OUTLINE OF NEW FEATURES

The following changes have been made for the new HIACE.

4. Engine

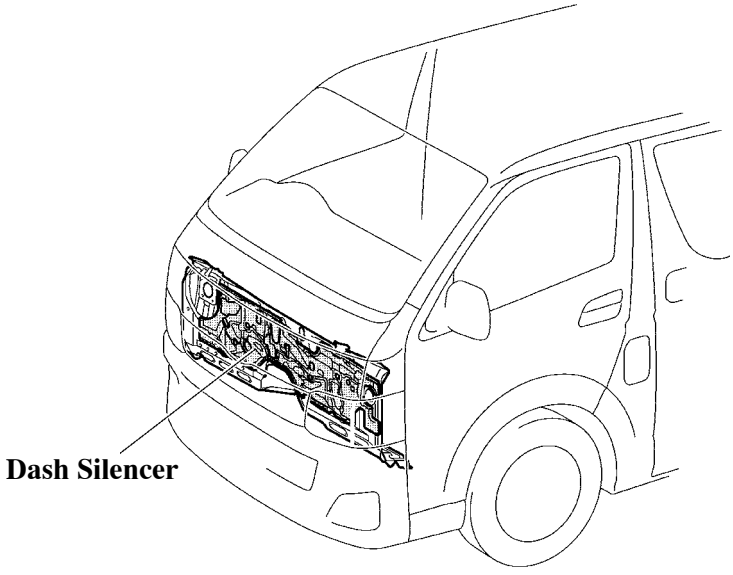
- It was decided that the 2TR-FE engine and 1KD-FTV engine for Hong Kong would comply with the EURO V regulations.
- The air cleaner shape has been changed from a square type to a round type for the 2TR-FE engine equipped vehicles for China and countries other than Hong Kong.
- A Brake Override System has been adopted for all models.

04Z5MO02

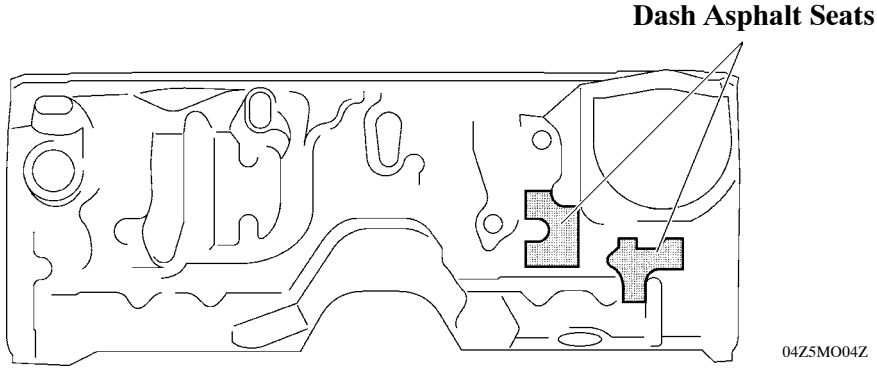
- Dash silencer has been provided for the 1KD-FTV engine equipped Hong Kong package models.

04Z5MO04Z

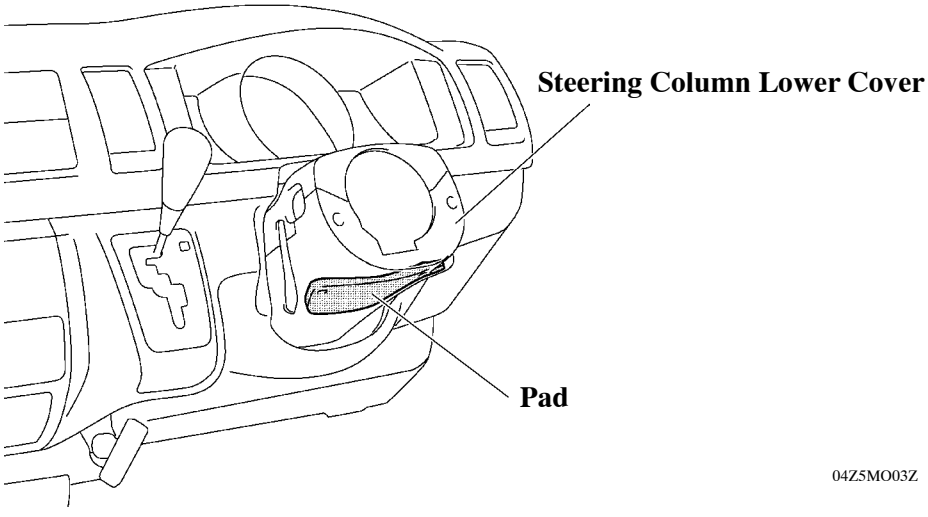
- Dash asphalt seats have been provided to the dash panel of the 1KD-FTV engine equipped Hong Kong package AT models.

7. Seat

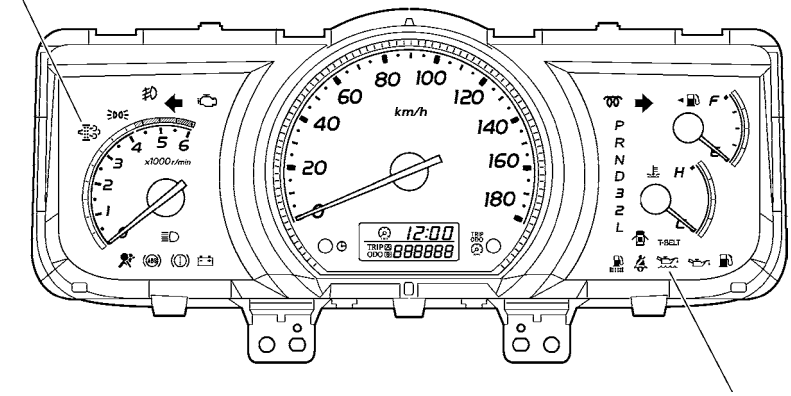
Rear seats with head rests are available as an option for the Super Long Commuter DX grade models for General Countries.
